**Proposed Private Plan Change – Campana Road
Clause 23 Request for Further Information Response (Transport)**

**Proposed Private Plan Change – Campana Road
Additional Clause 23 Request for Further Information Response (Transport)**

**Proposed Private Plan Change – Campana Road
Clause 23 Request for Further Information Response (Transport)**

**Proposed Private Plan Change – Campana Road
Clause 23 Request for Further Information Response (Transport)**

SITE LAYOUT

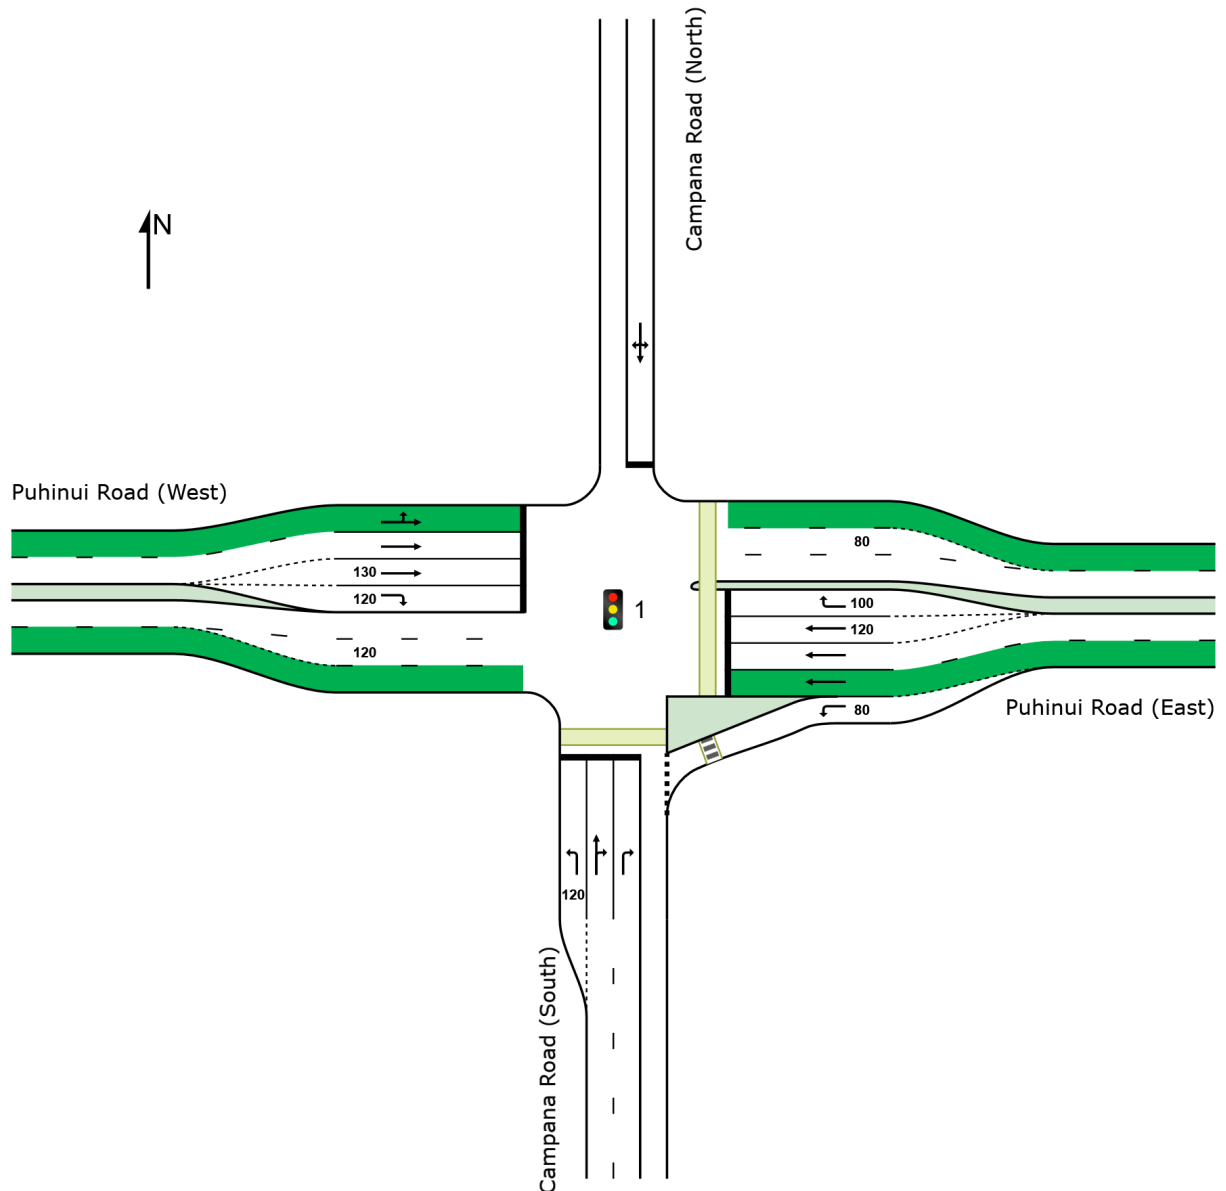
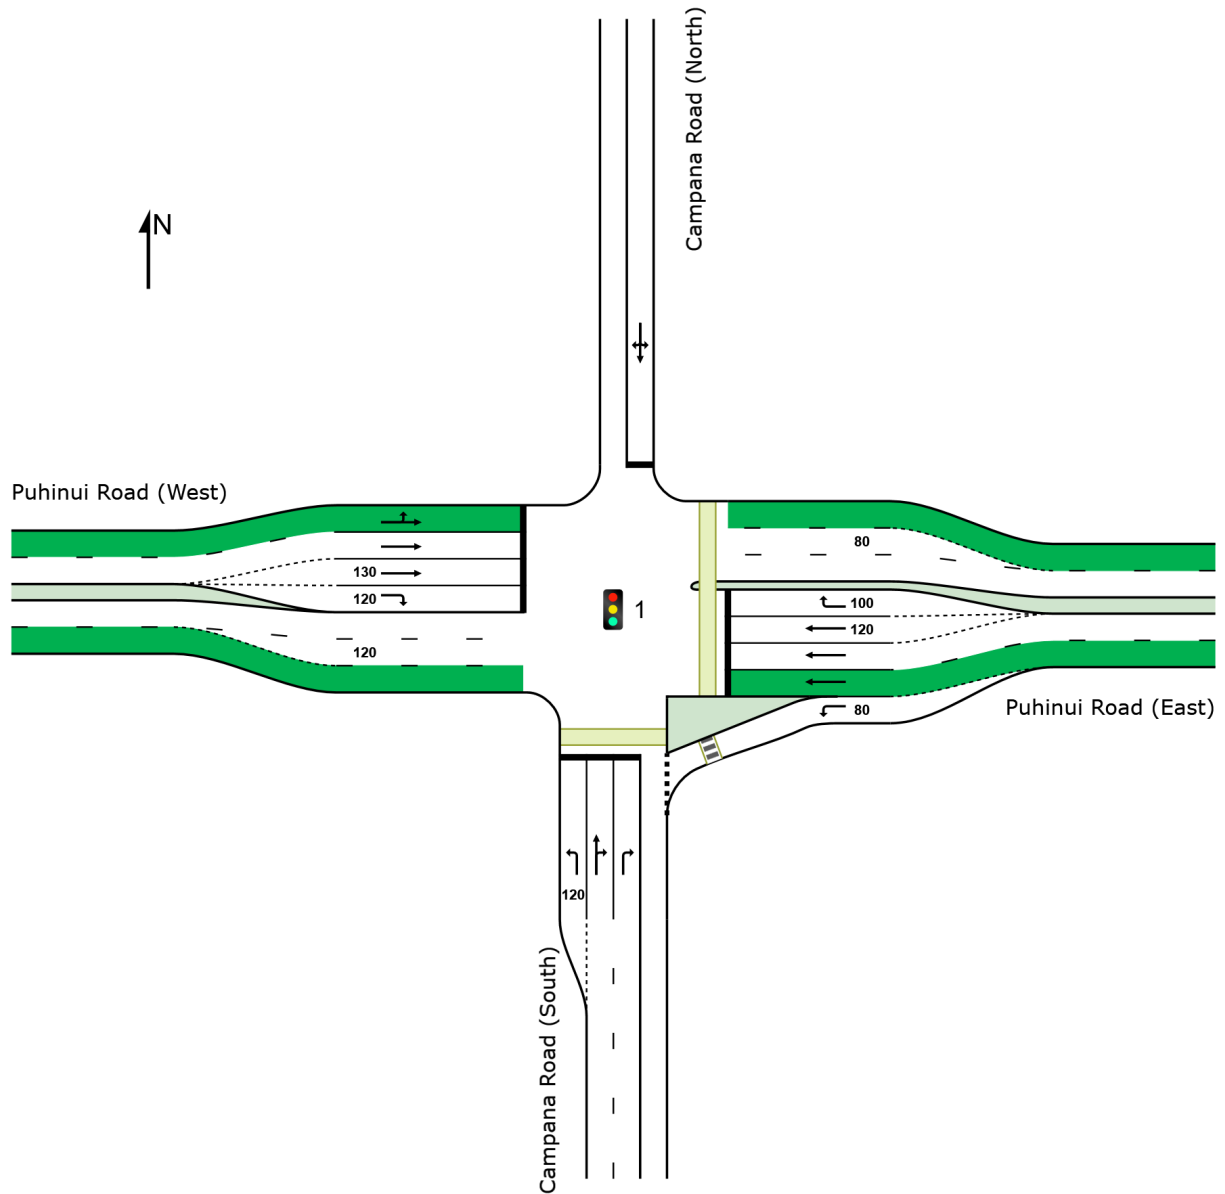
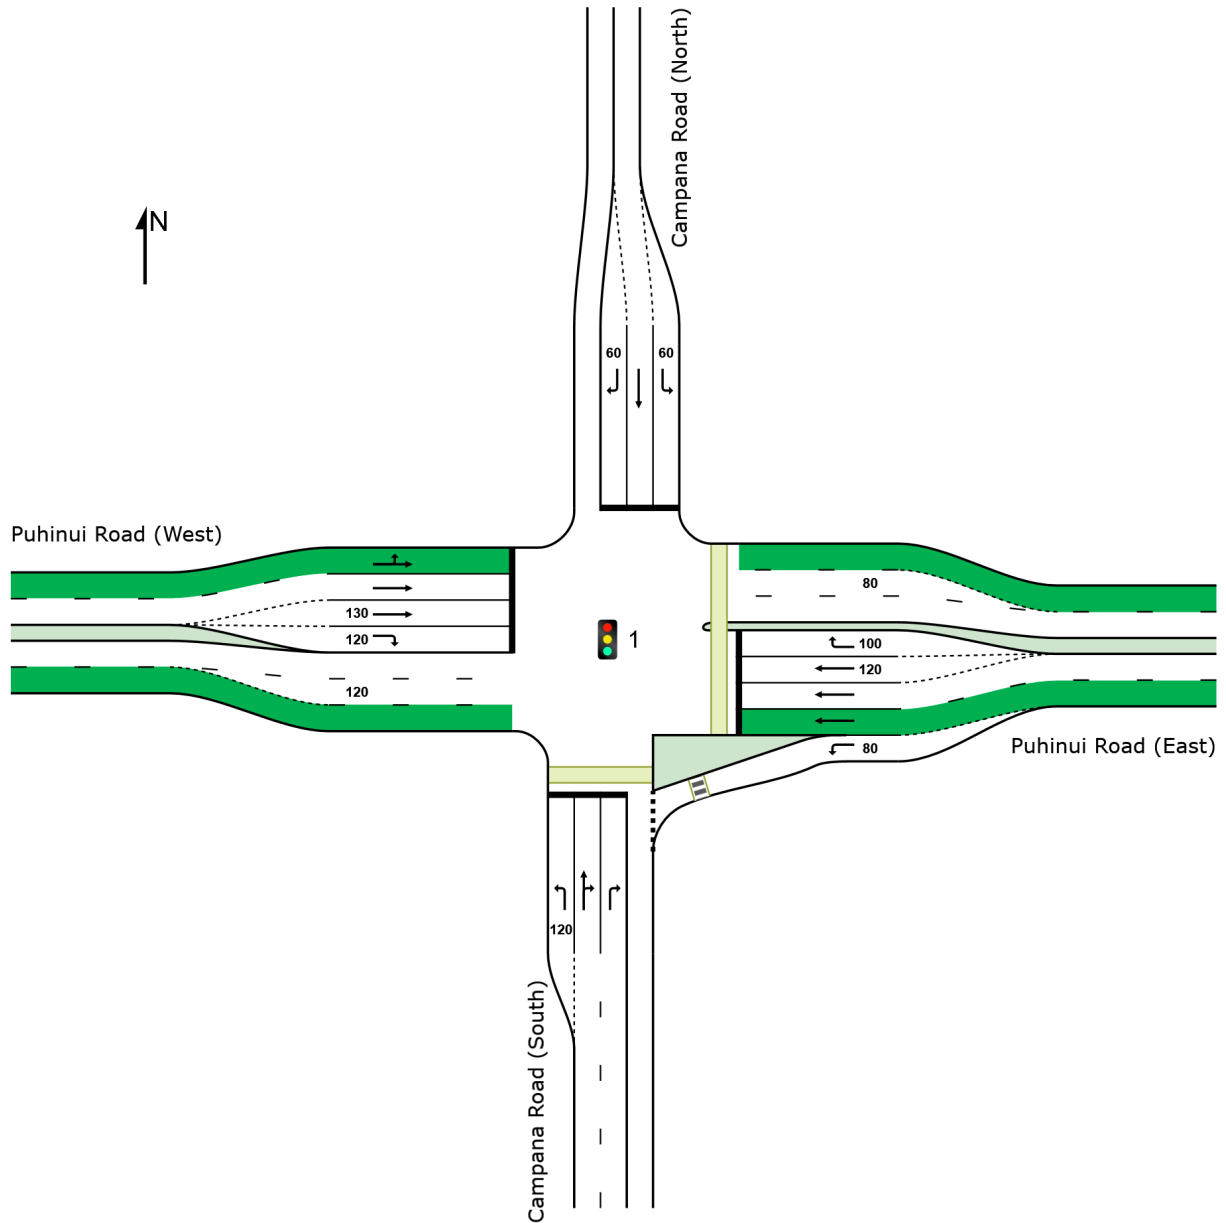
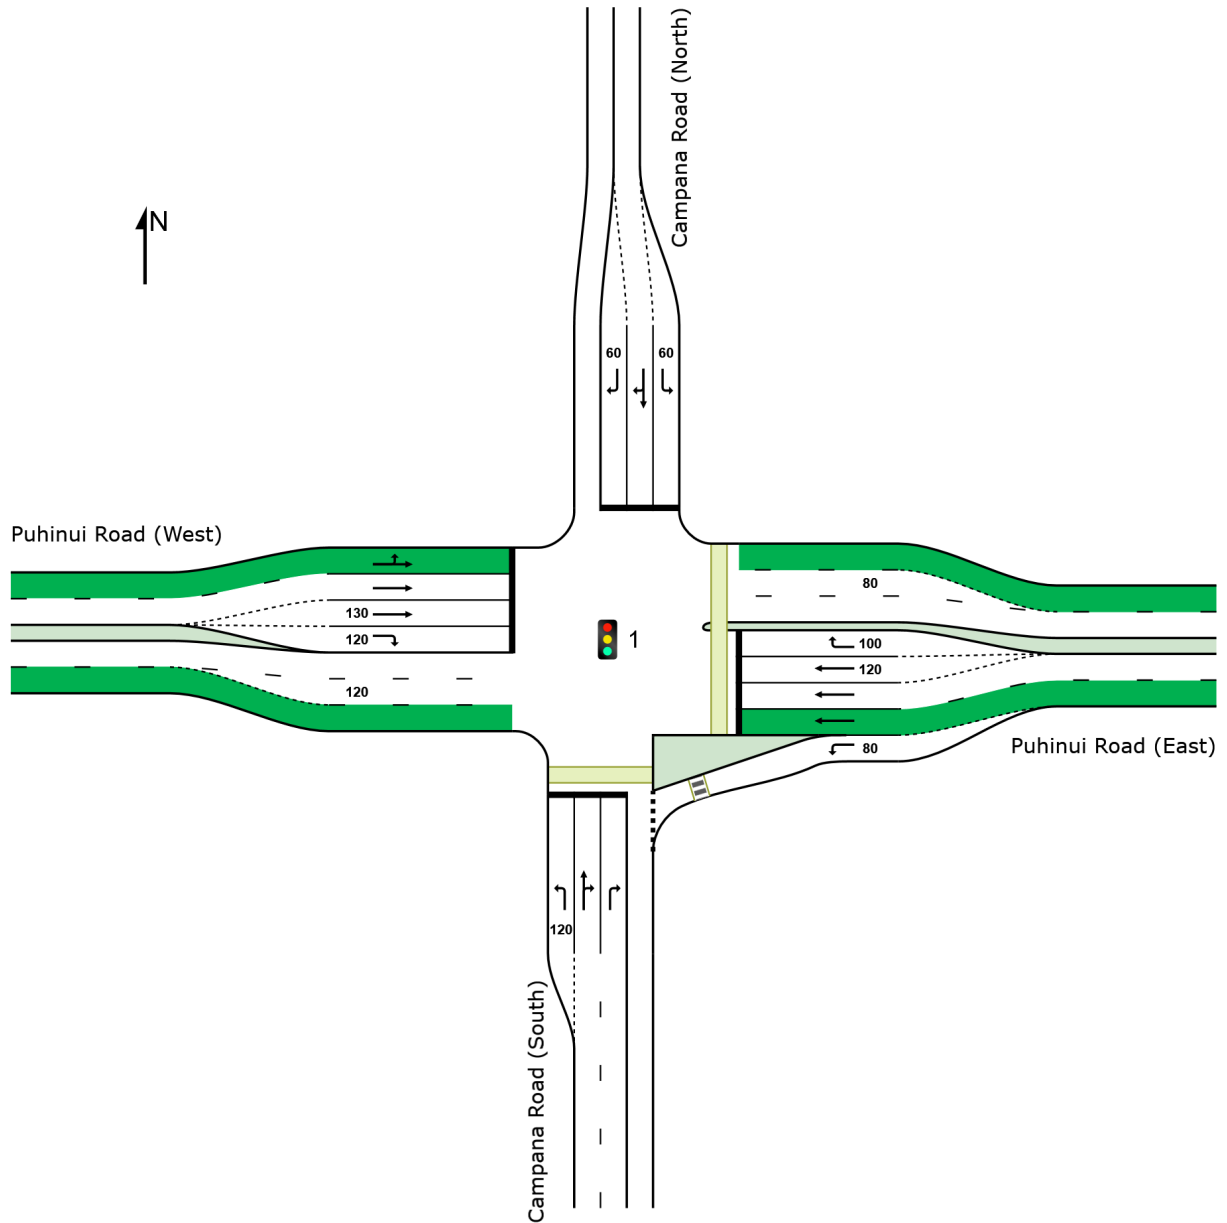
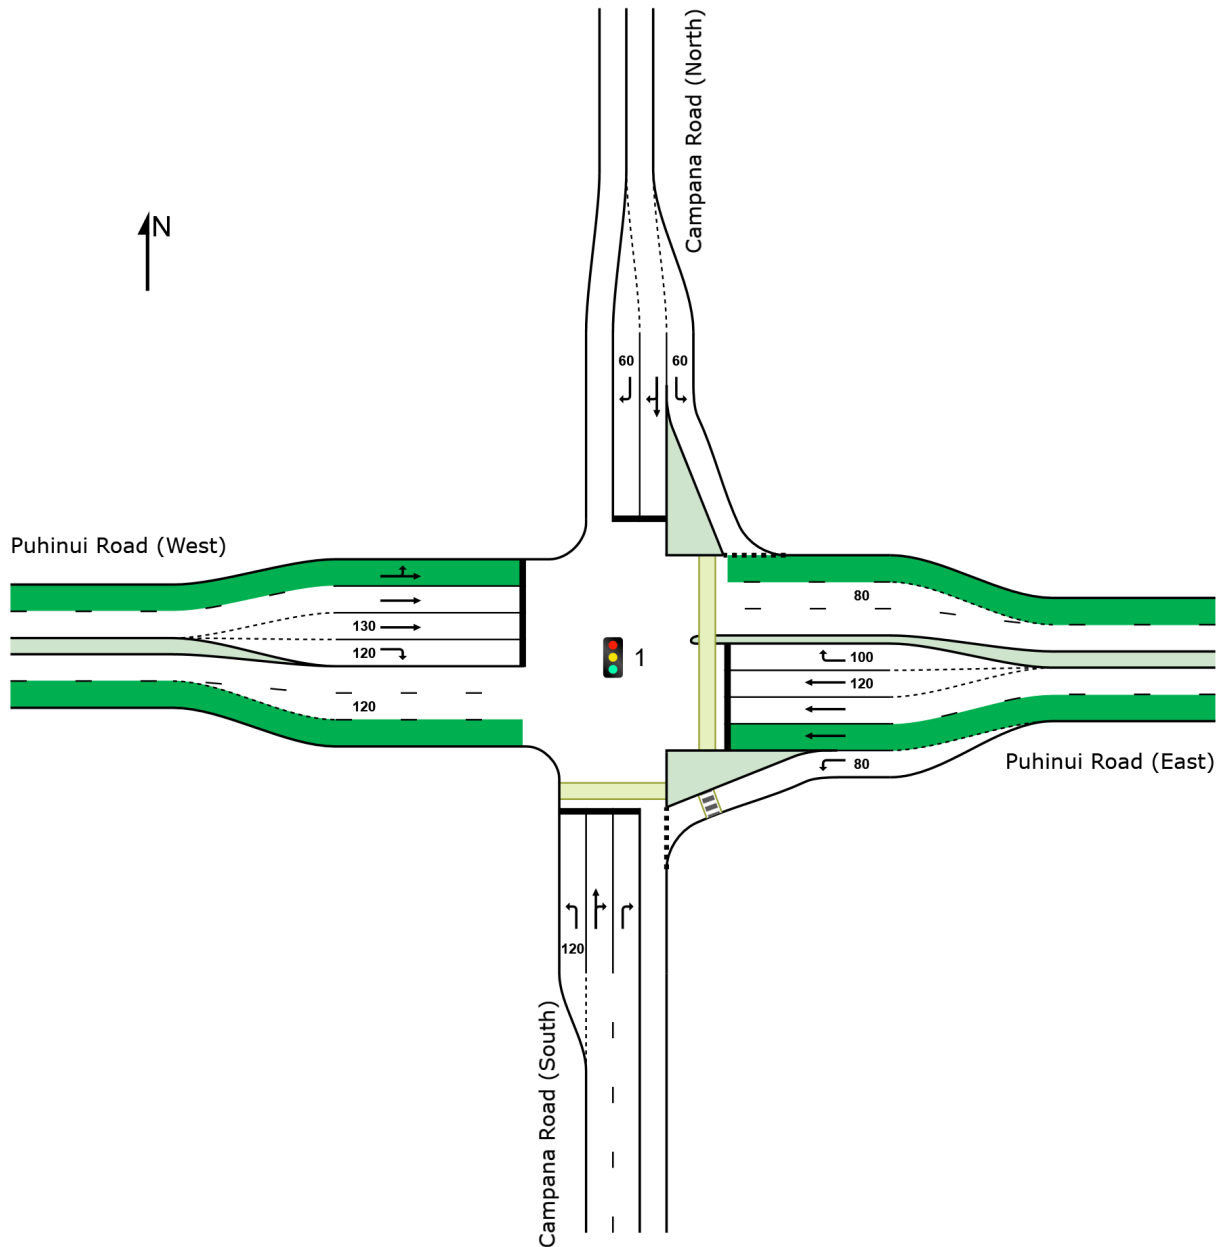
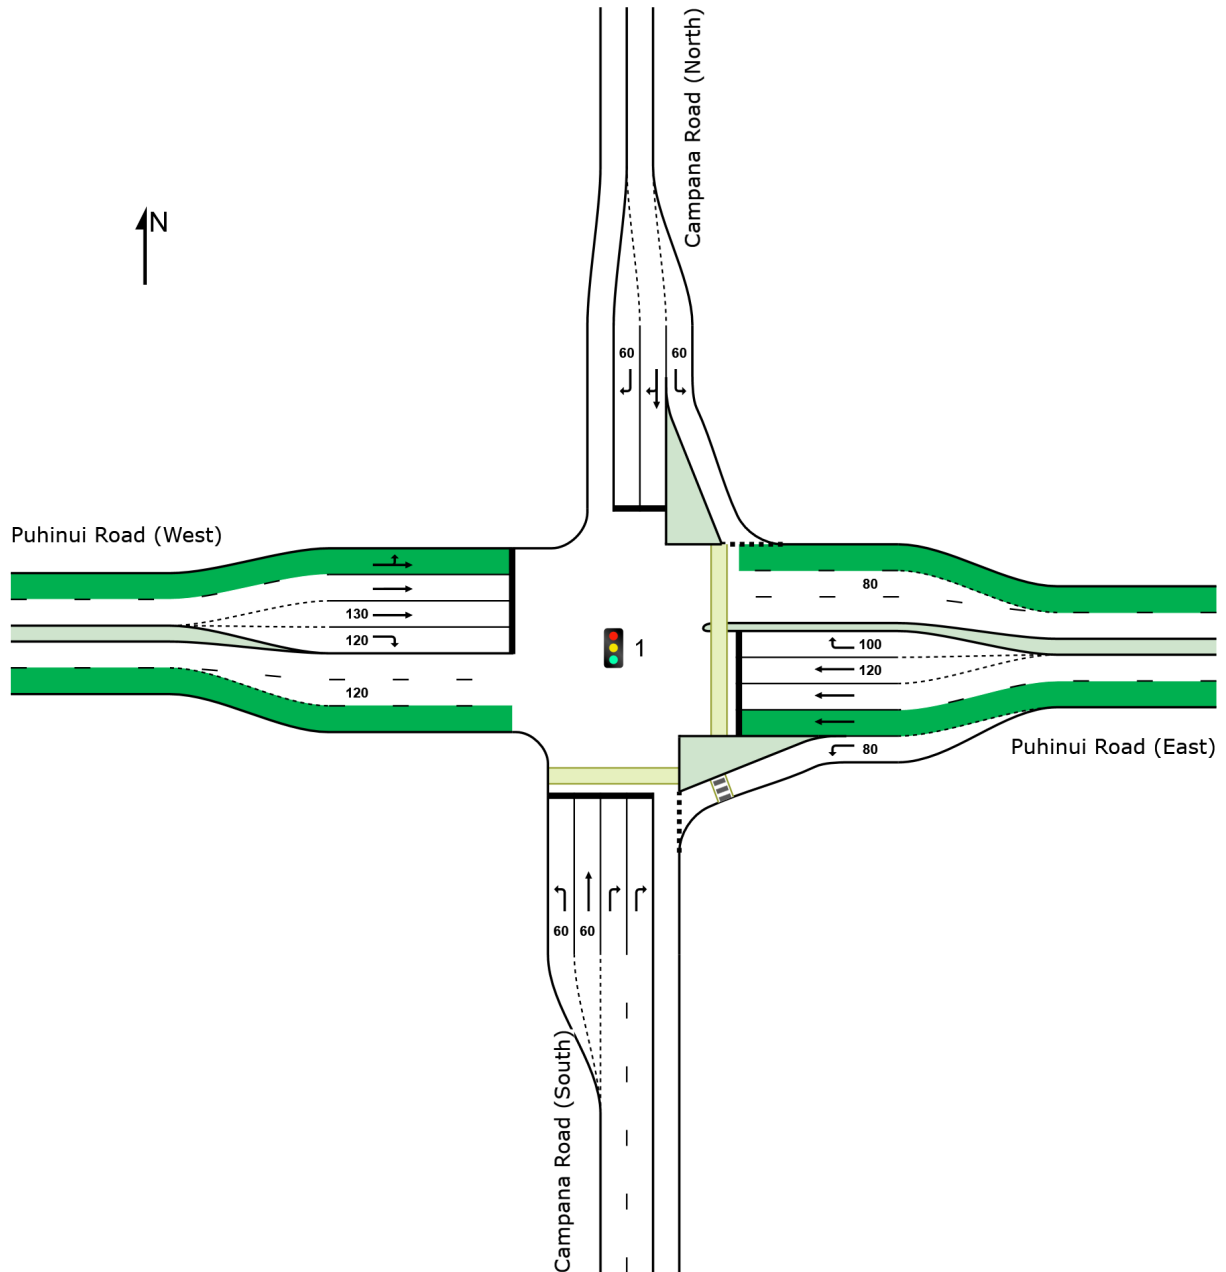
Please also provide summaries of traffic modelling results to confirm intersection capacities / Levels of Service, etc.

The SIDRA traffic modelling results are attached for the existing layout and the four possible improvement options discussed in the Second RFI response (19 November 2024).
